Improved tie rod end Audi, Skoda & Volkswagen

SIDEM	TOEPASSING	N° OE
37630 R	tie rod end	Audi A4	4F0 419 811 E
		Audi A6	
		Audi A8	
		Skoda Superb	
		VW Passat IV/V

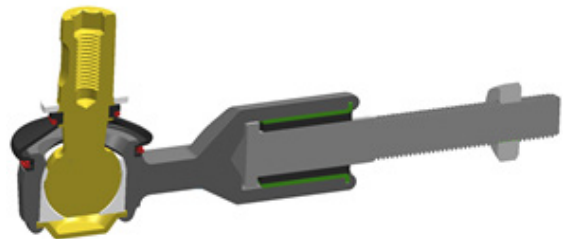
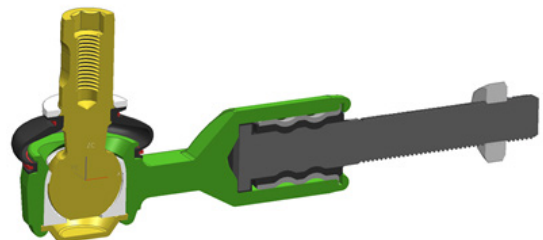
- Reduced lifetime

- Silent block tears out
- Silent block becomes softer during time

- The silent block is replaced by a rigid connection

- Longer lifetime
- No loss of steering accuracy
